Gregory Site Stream and Wetland Mitigation Plan Halifax County, NC

June 2004

We are in receipt of your correspondence of May 6, 2004 wherein you provided comments regarding the restoration plan for the Gregory site in Halifax County. Below are our responses to each of the comments:

CONSTRUCTED BERM

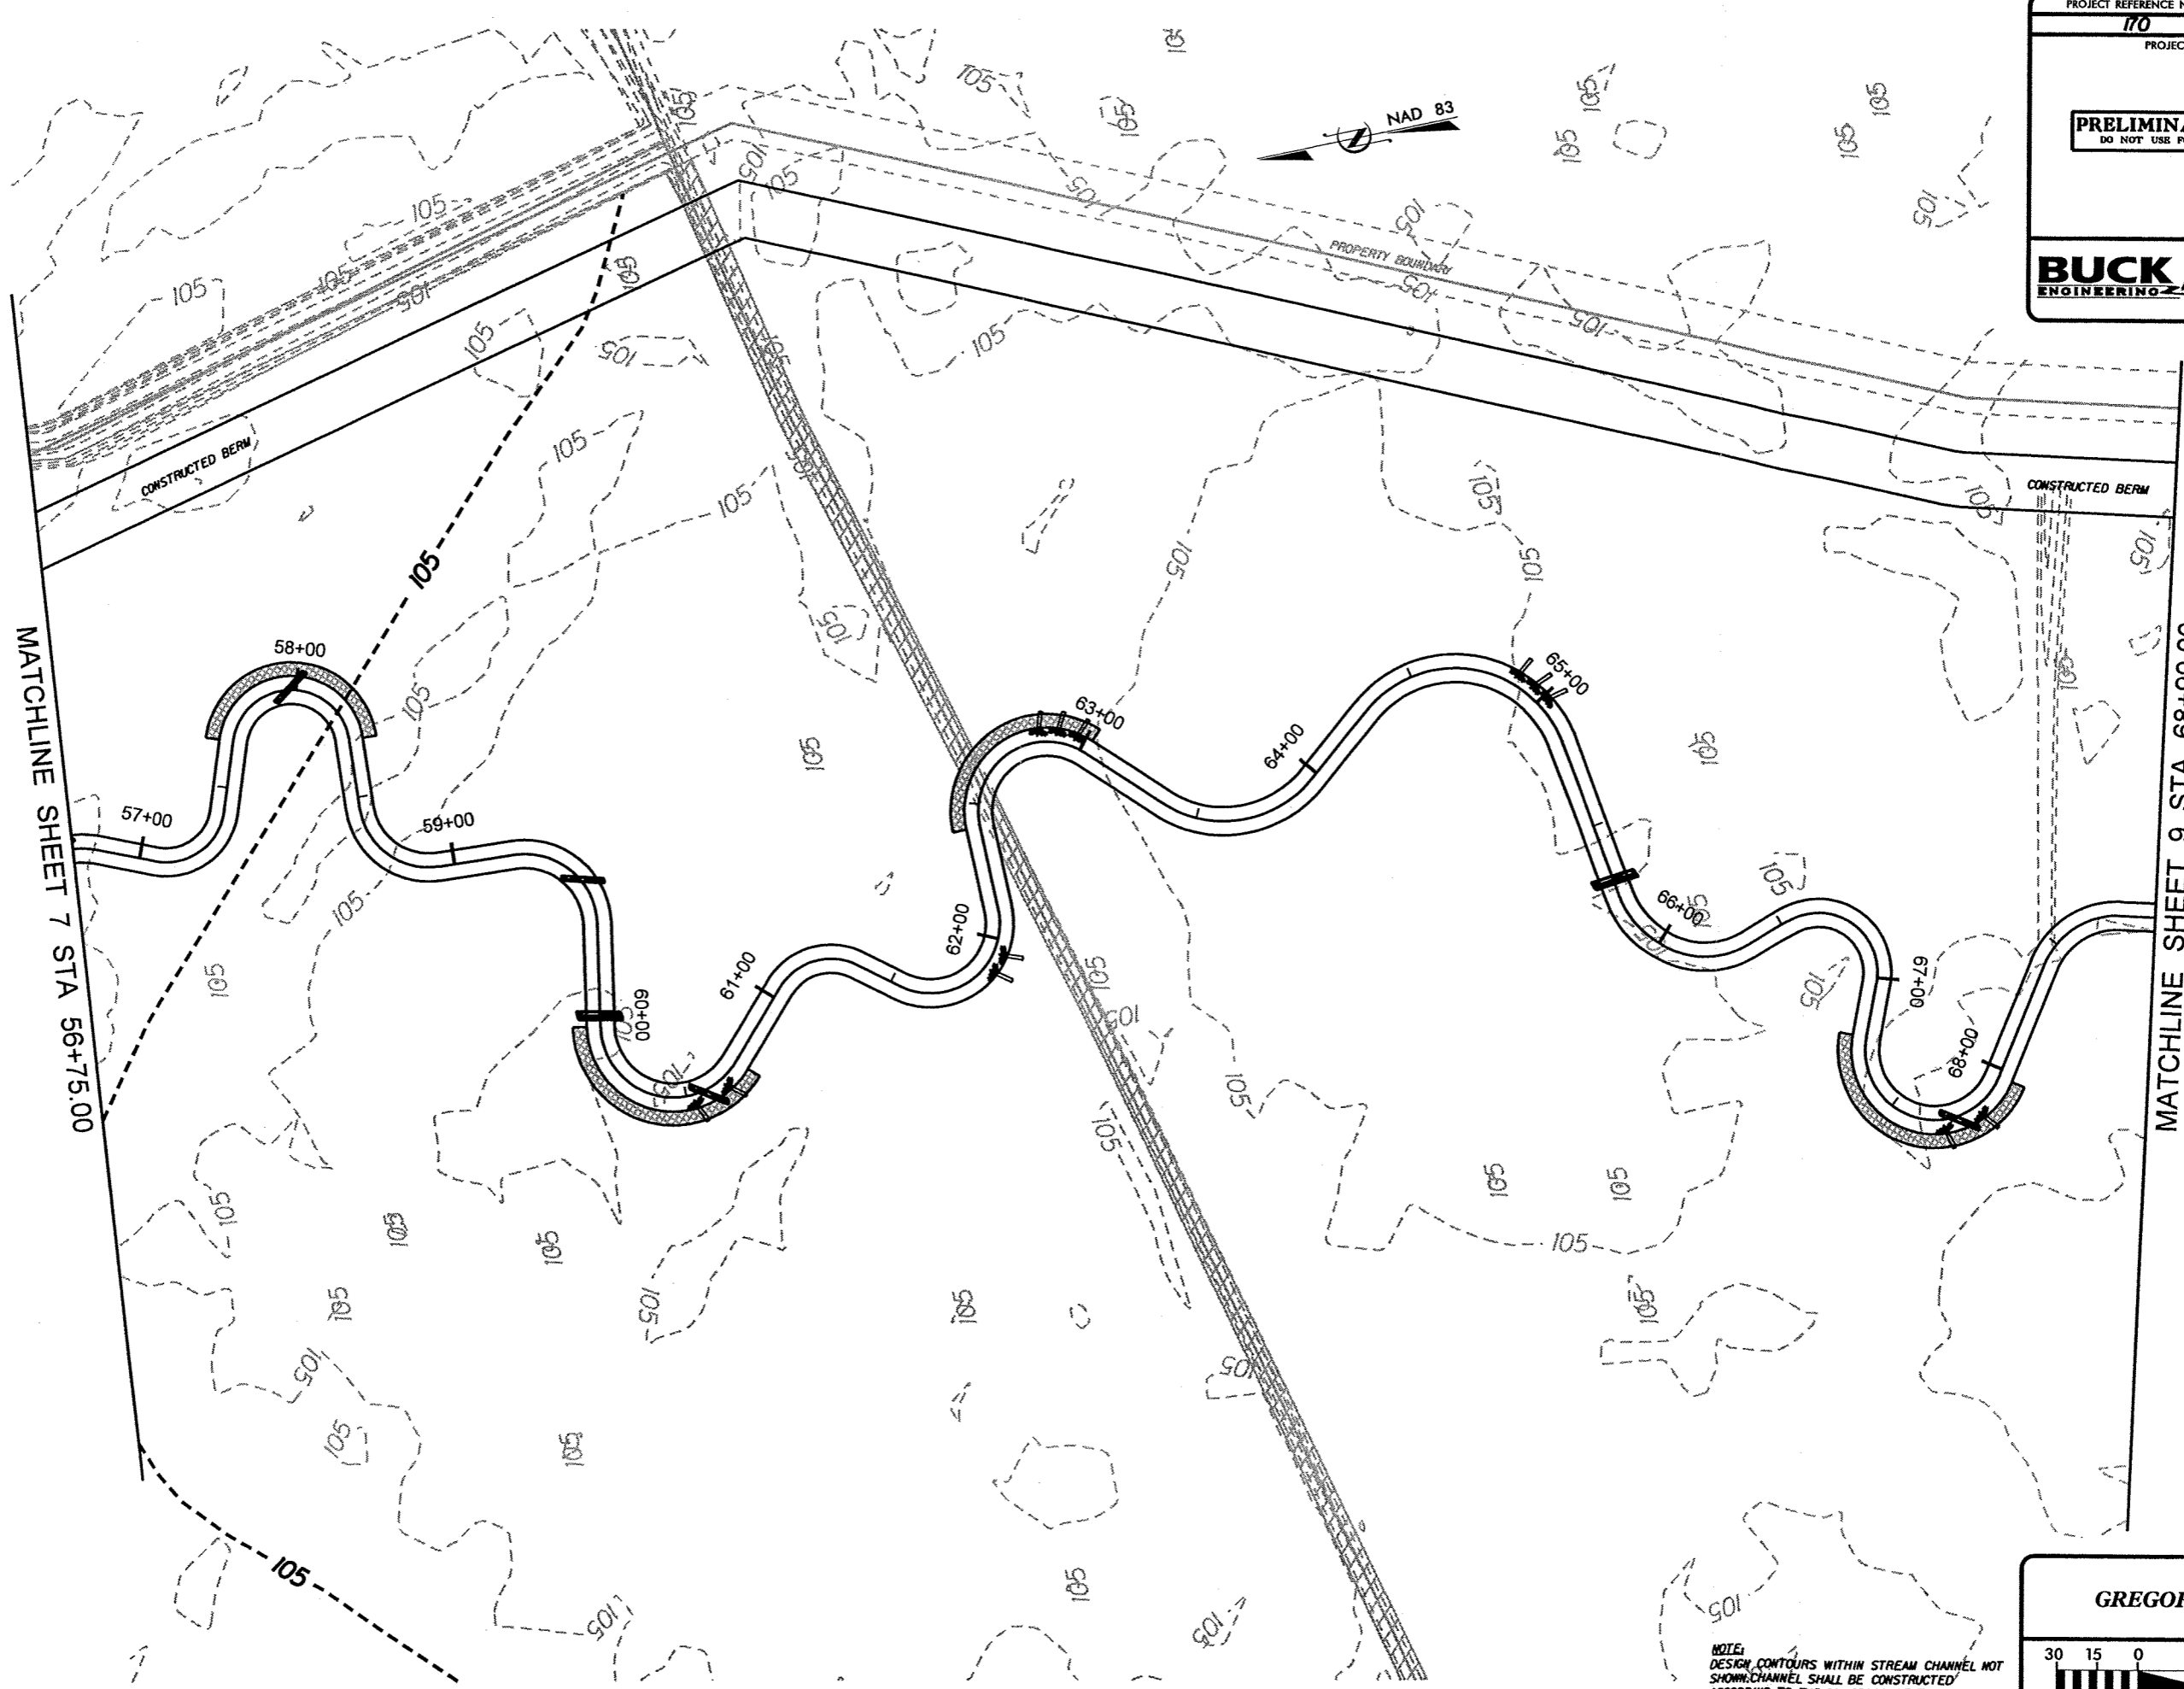
EEP Comment Page 7-1) EEP would like more clarification on the use of berms. Would flood waters not just drain into the large ditch instead of flooding adjacent properties? Berms should not be used to maximize wetland hydrology, thus approaching more of a constructed wetland.

This berm is necessary to prevent off-site flooding. This issue is now discussed in greater detail on page 7-1 of the attached restoration plan.
